dsPIC33FJ06GS001/101A/102A/202A and dsPIC33FJ09GS302 Family Silicon Errata and Data Sheet Clarification

The dsPIC33FJ06GS001/101A/102A/202A and dsPIC33FJ09GS302 family devices that you have received conform functionally to the current Device Data Sheet (DS75018C), except for the anomalies described in this document.

FIGURE 1: TIMING DIAGRAMS FOR CENTER-ALIGNED AND EDGE-ALIGNED MODES

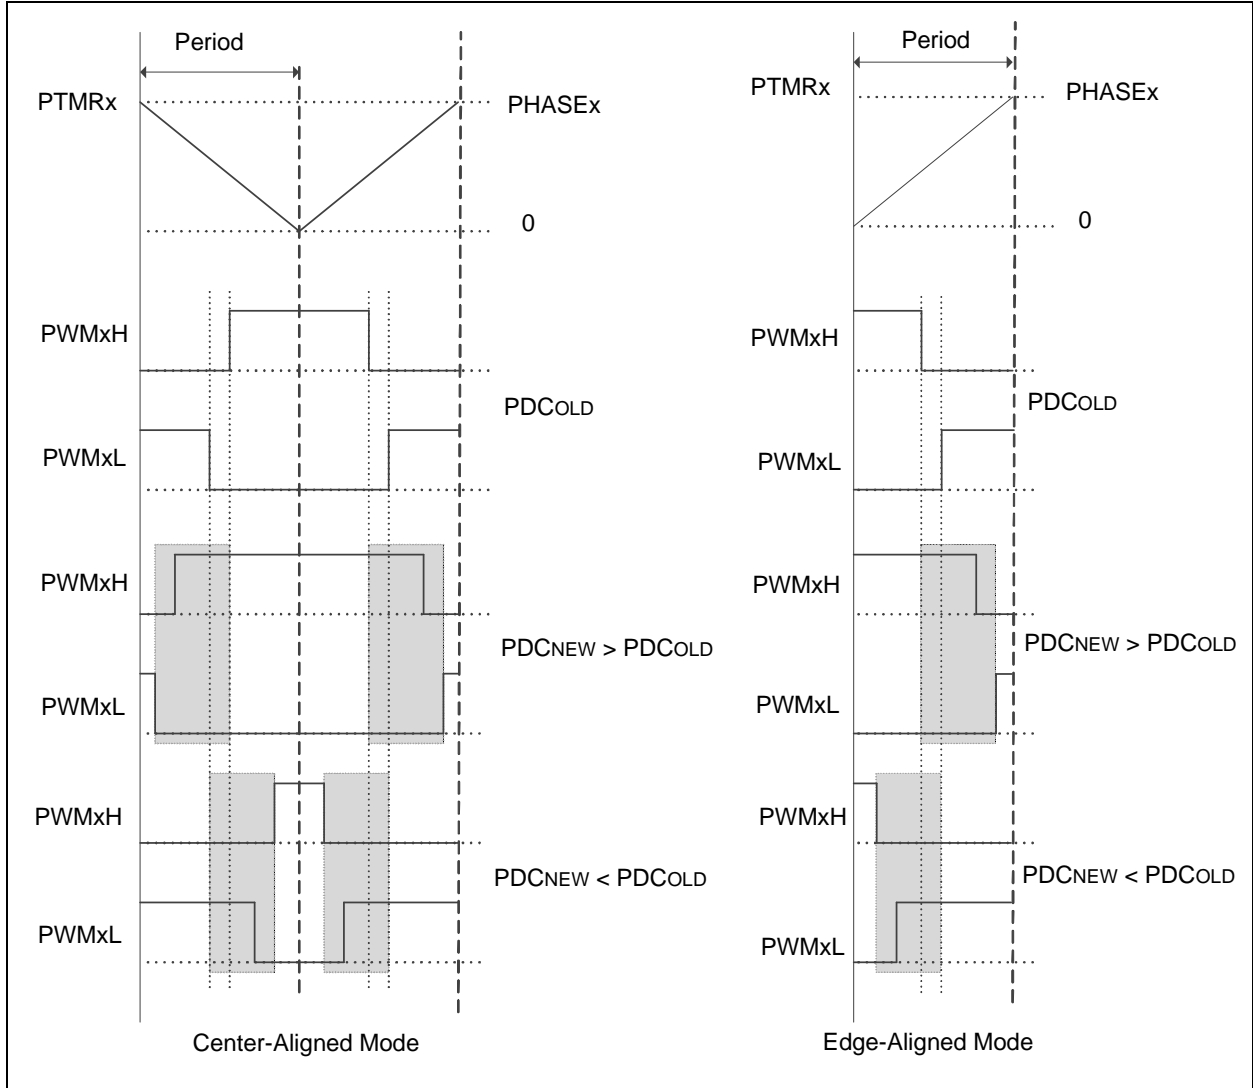
The PWMx generator may not assert dead time on the edges of transitions. This has been observed when all of the following conditions are present:

- The PWMx generator is configured to operate in Complementary mode with the independent time base or master time base;
- Immediate update is enabled; and
- The value in the PDCx register is updated in such a manner that the PWMxH and PWMxL outputs make an immediate transition.

The current duty cycle, PDCOLD, newly calculated duty cycle, PDCNEW, and the point at which the write to the Duty Cycle register occurs within the PWMx time base, will determine if the PWMxH and PWMxL outputs make an immediate transition. PWMxH and PWMxL outputs make an immediate transition if the Duty Cycle register is written with a new value, PDCNEW, at a point of time when the PWMx time base is counting a value that is in between PDCNEW and PDCOLD. Additionally, writing to the Duty Cycle register close to the instant of time where dead time is being applied may result in reduced dead time, effective on the PWMxH and PWMxL transition edges.

In [Figure 1](#) (following page), if the duty cycle write occurred in the shaded box, then PWMxH and PWMxL will make an immediate transition without dead time.

None. However, in most applications the duty cycle update timing can be controlled using the TRIGx trigger or Special Event Trigger such that the above mentioned conditions are avoided altogether.

FIGURE 2: ISSUE EXAMPLE FOR REDUNDANT OUTPUT MODE

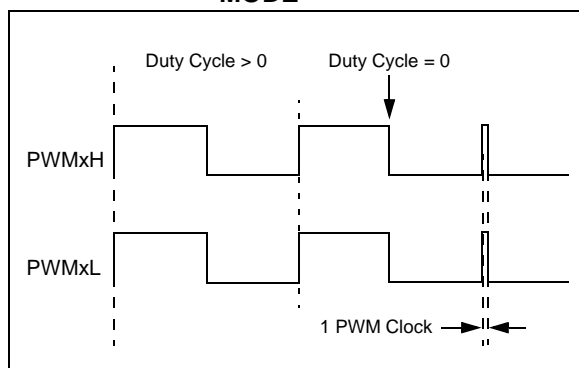
In Redundant Output mode (IOCONx<11:10> = 01) and Push-Pull Output mode (IOCONx<11:10> = 10) with the Immediate Update Enable bit (PWMCONx<0> = 0) disabled, when the Duty Cycle register is updated from a non-zero value to zero, a glitch pulse of a width equal to 1 PWM clock will appear at the next PWM period boundary, as shown in Figure 2 (for the Redundant Output mode). The Duty Cycle register refers to the PDCx register if PWMCONx<8> = 0 or the MDC register if PWMCONx<8> = 1.

If the application requires a zero duty cycle output, there are two possible work around methods:

1. Use the PWM override feature to override the PWM output to a low state instead of writing to the Duty Cycle register. In order to switch back to a non-zero duty cycle output, turn off the PWM override. The override-on and override-off events must be timed close to the PWM period boundary if the IOCONx register has been configured with IOCONx<0> = 0 (i.e., output overrides through the OVRDAT<1:0> bits occur on the next CPU clock boundary).
2. Enable the Immediate Update Enable bit (PWMCONx<0> = 1) while configuring the PWMx module (i.e., before enabling the PWMx module, PTCON<15> = 1). With the Immediate Update enabled, writes to the Duty Cycle register can have an immediate effect on the PWM output. Therefore, the duty cycle write operations must be timed close to the PWM period boundary in order to avoid distortions in the PWM output.

FIGURE 3: ISSUE EXAMPLE IN PUSH-PULL MODE

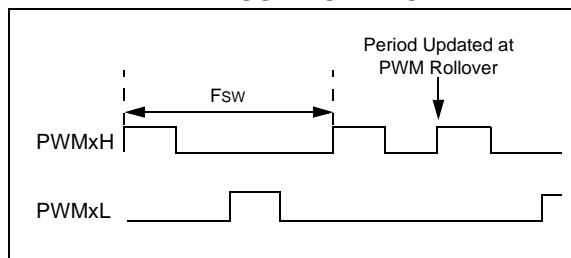
When the PWM module is configured for Push-Pull mode (IOCONx<11:10> = 10) with the Enable Immediate Period Updates bit enabled (PTCON<10> = 1), a write to the Period register that coincides with the period rollover event may cause the push-pull output logic to produce back-to-back pulses on the PWMx output pins (Figure 3).

Use either the PWMx Special Event Compare (SEVTCMP) or PWMx Primary Trigger Compare Value (TRIGx) to generate a PWM Interrupt Service Routine (ISR) near the start of the PWM cycle. This ISR will ensure that period writes do not occur near the PWM period rollover event.

FIGURE 19-2: ADC BLOCK DIAGRAM FOR THE dsPIC33FJ06GS101A DEVICE

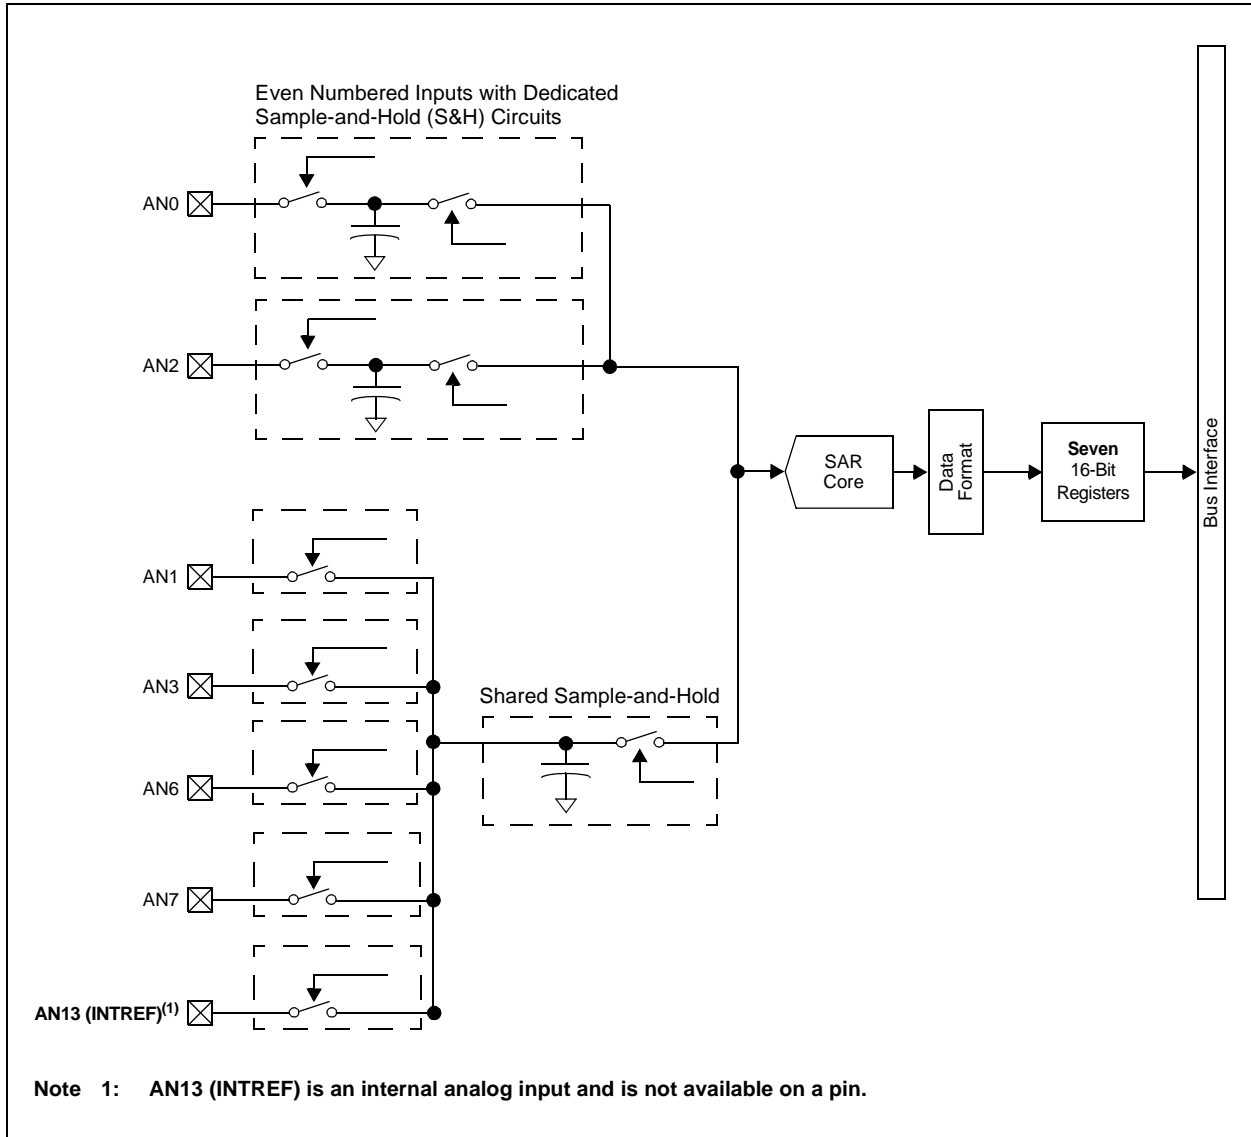
In [Figure 19-2](#) and [Figure 19-3](#), AN13 has been added and the number of output registers has been changed from eight to seven.

FIGURE 19-5: ADC BLOCK DIAGRAM FOR THE dsPIC33FJ09GS302 DEVICE

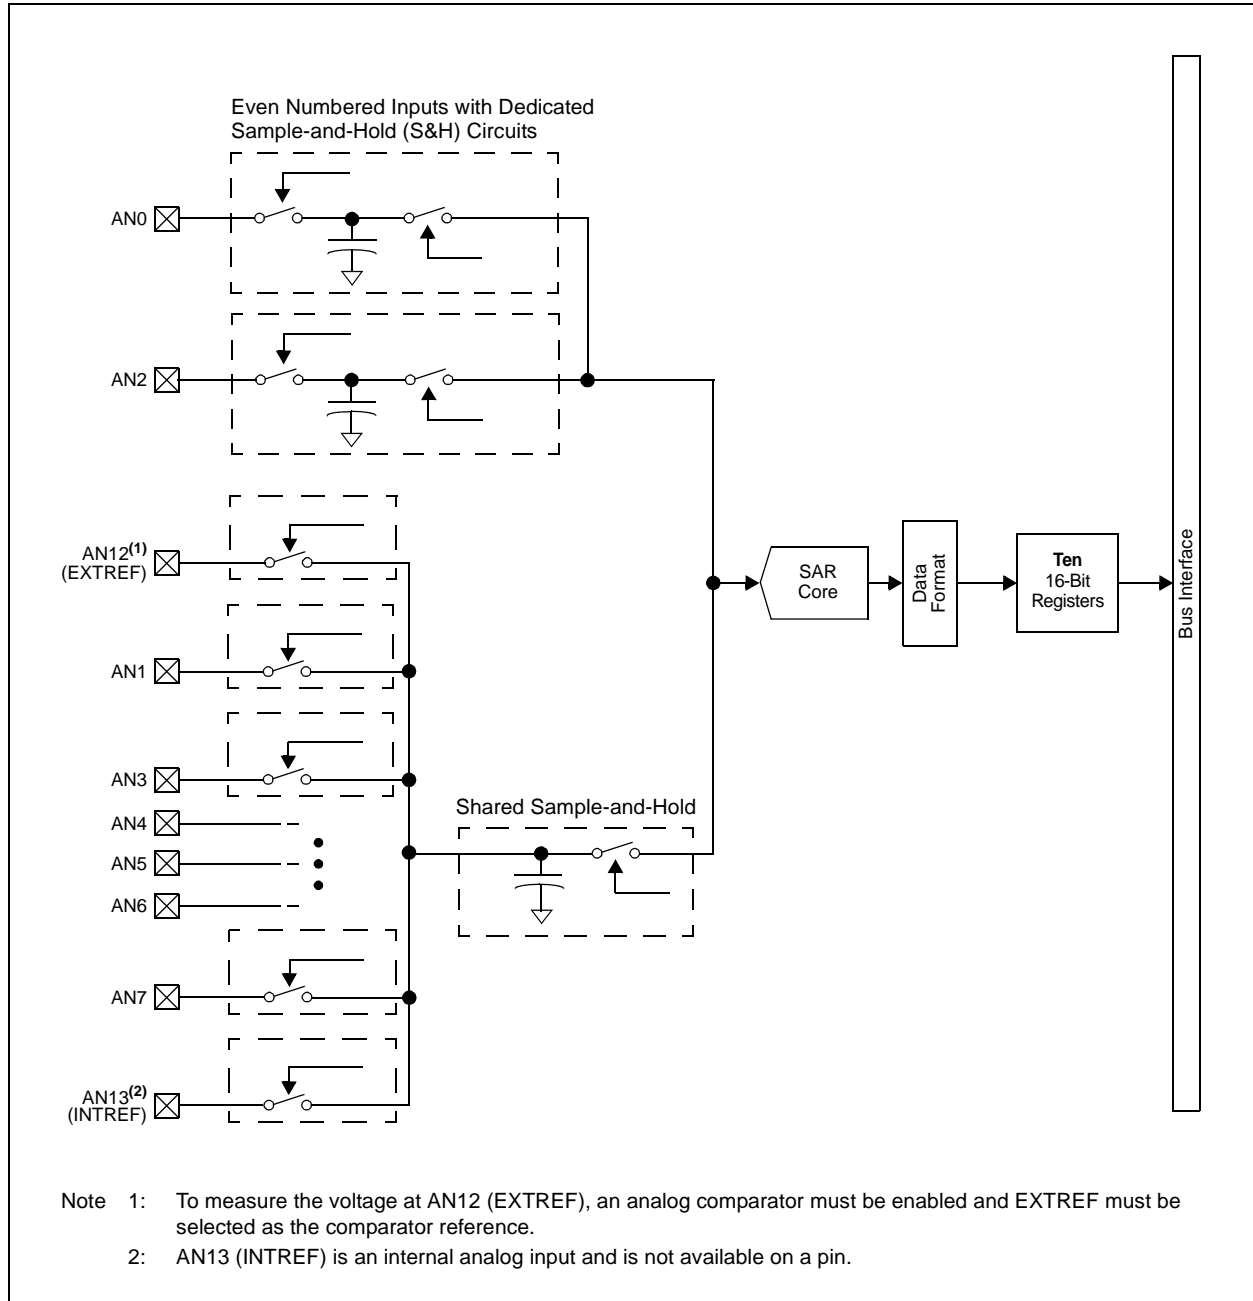
In [Figure 19-5](#), the number of output registers has been changed from eight to ten. The changes are shown in bold below:
